To: Design Review Board
From: Angela Ruggeri, Senior Planner
Date: December 20, 2013
File No.: DRV13-02199
Subject: 220 6th Street Flats
CONCEPTUAL DESIGN CONFERENCE

220 6TH AVE FLATS

CONCEPTUAL DESIGN CONFERENCE

MASSING SCHEME 3 (PREFERRED)

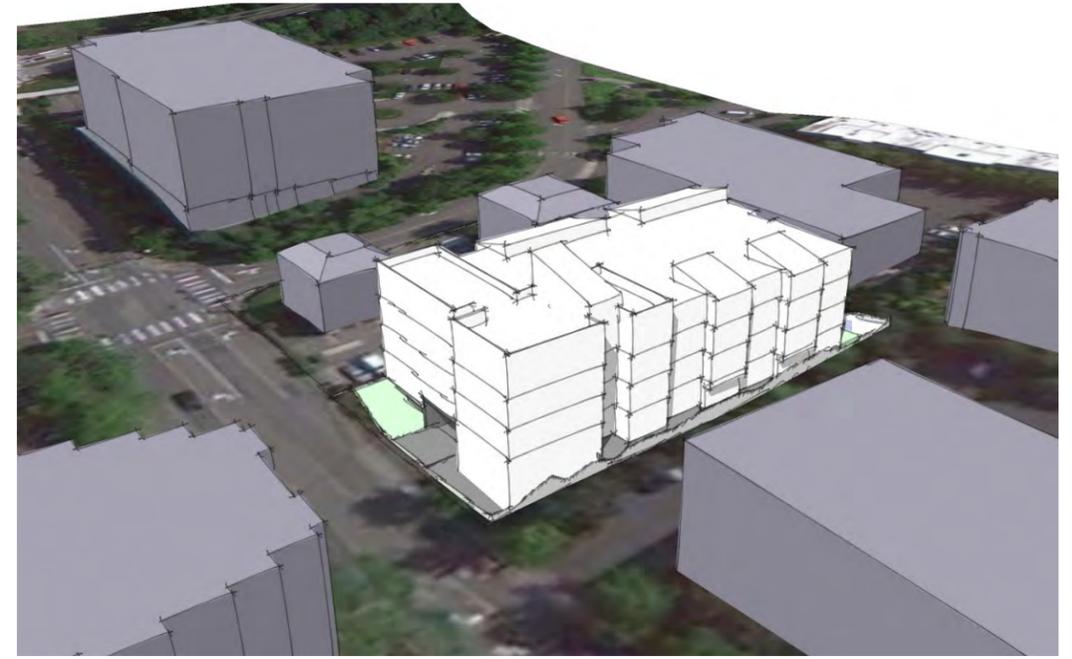
1. What are the key vantages of the project?
2. Identify appropriate mitigation techniques for building massing of the proposed buildings. Possible techniques include vertical and horizontal modulation and roof forms. The applicant has provided several massing schemes including a preferred Massing Scheme 3 for the DRB's review and comment (see Attachment 1, page 12).

DEPARTURE I

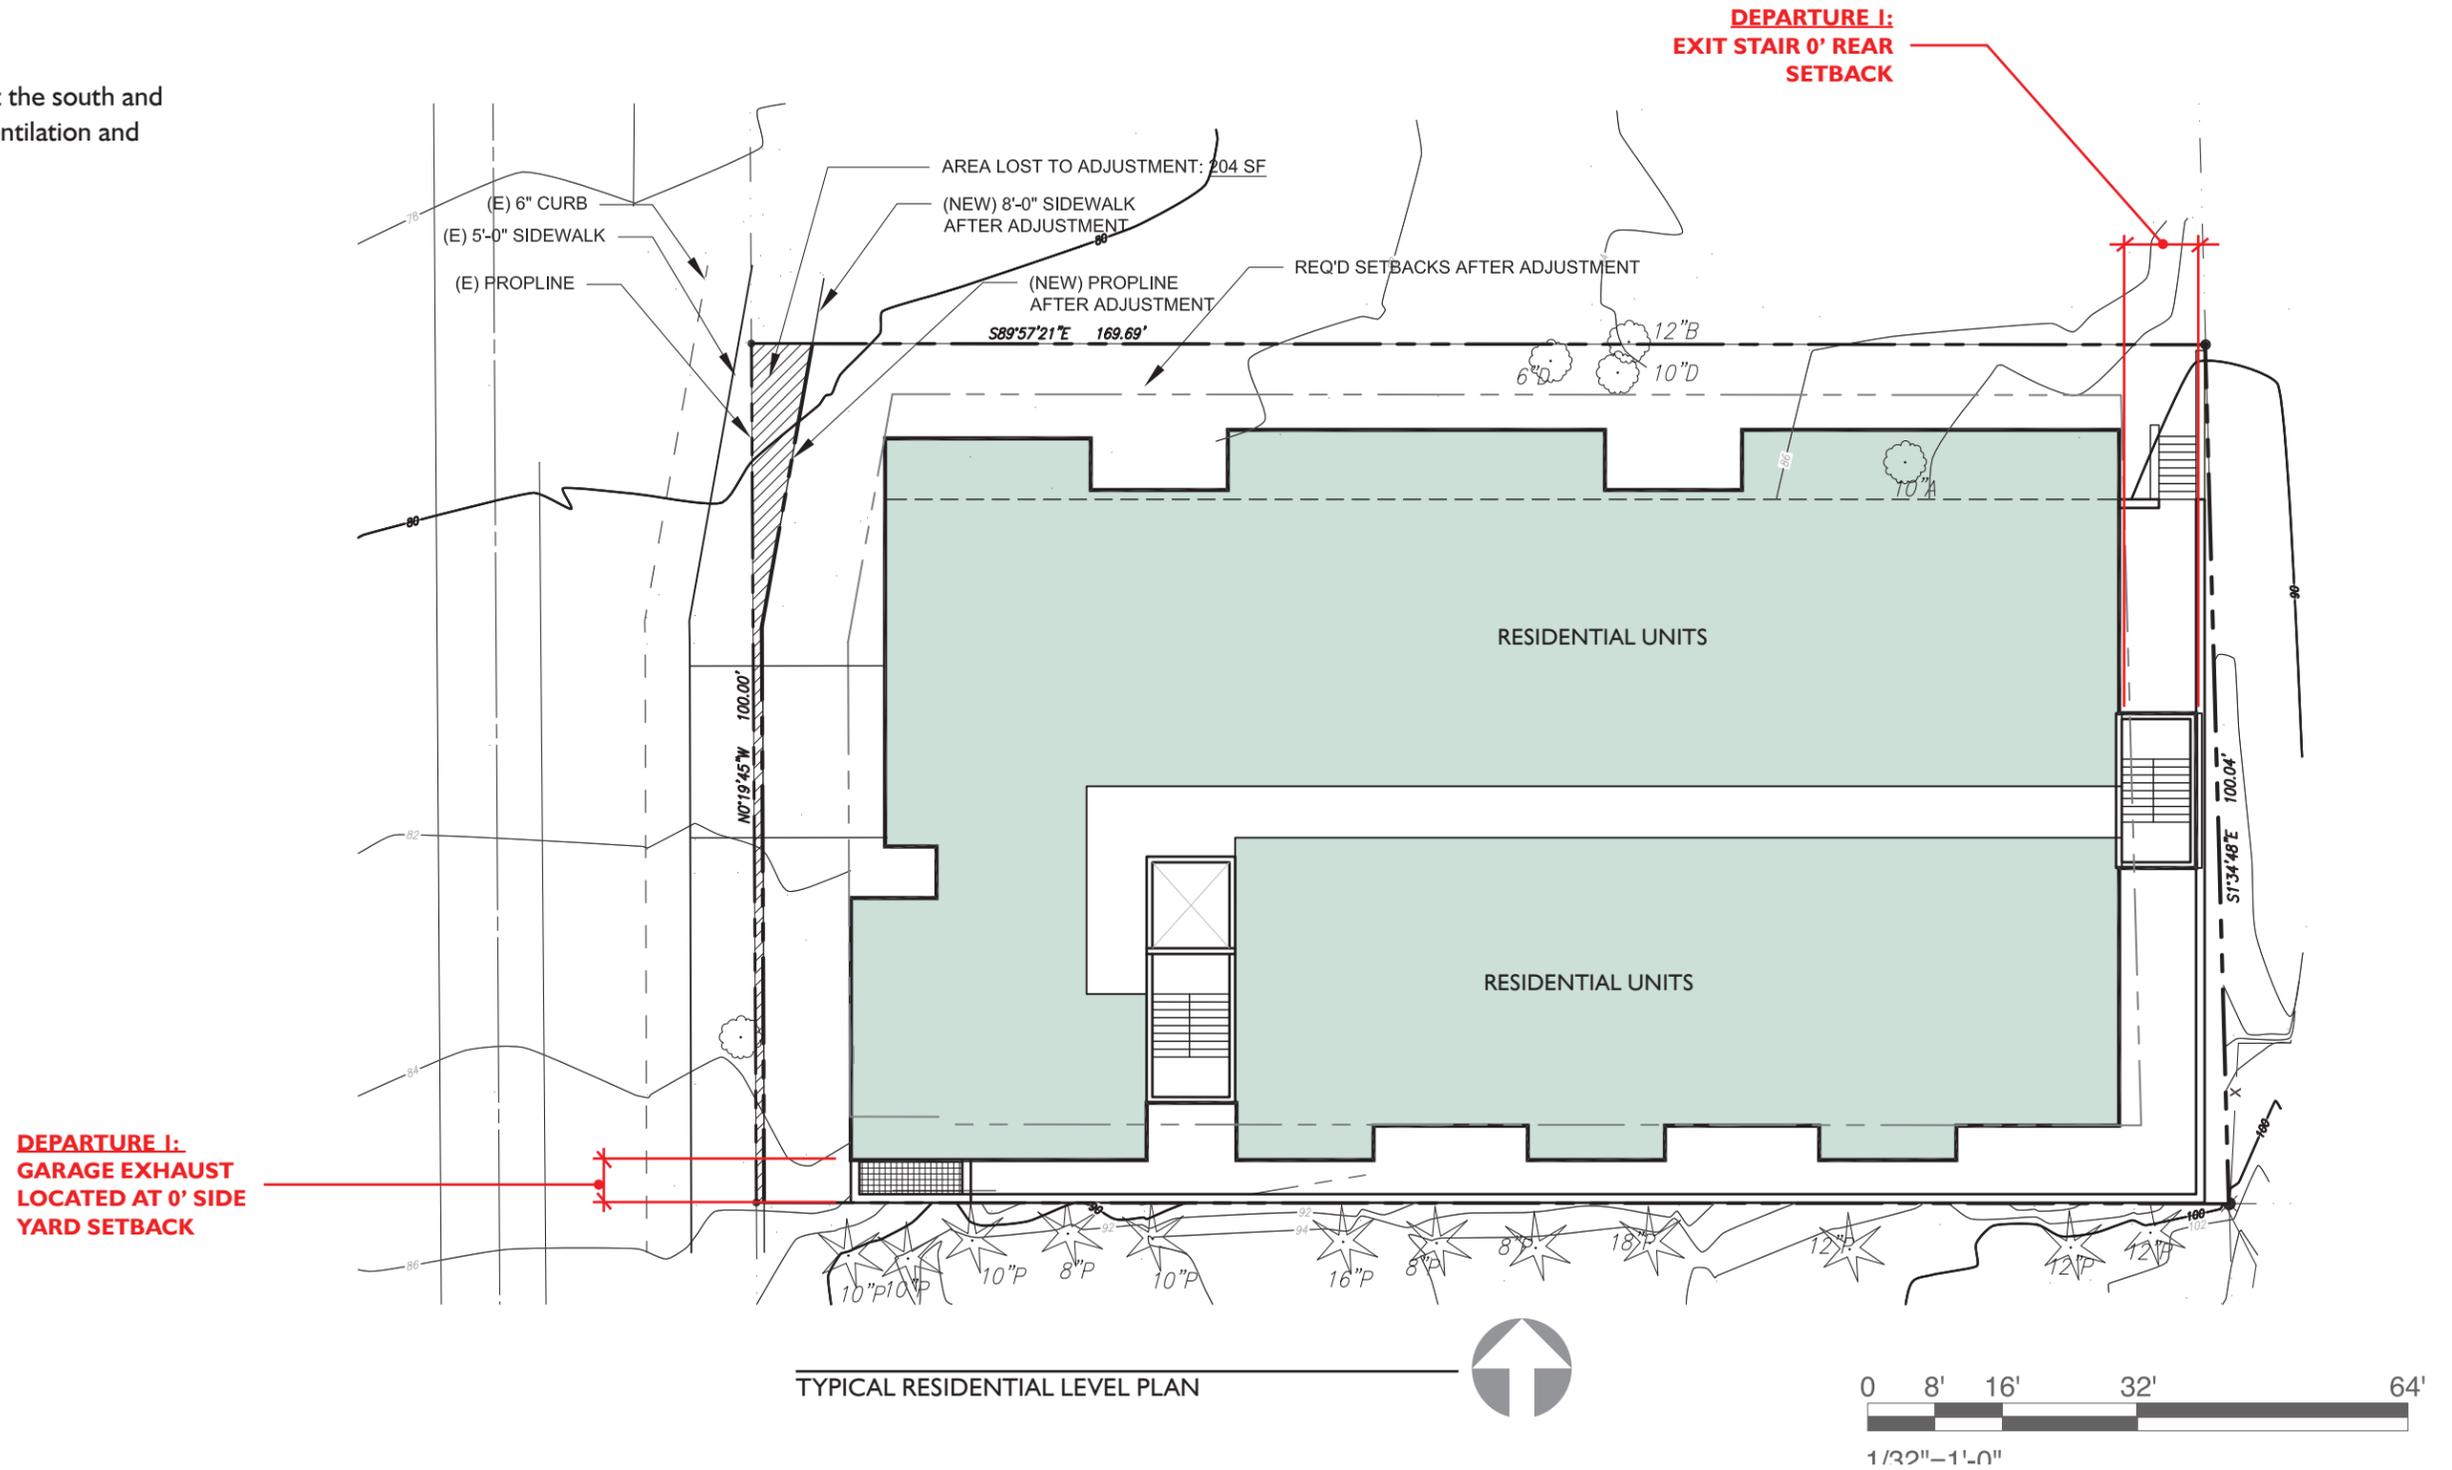
Does the DRB have preliminary comments on the setback reduction requests as they relate to the minor variation approval criteria (superior design and no detrimental effects)?
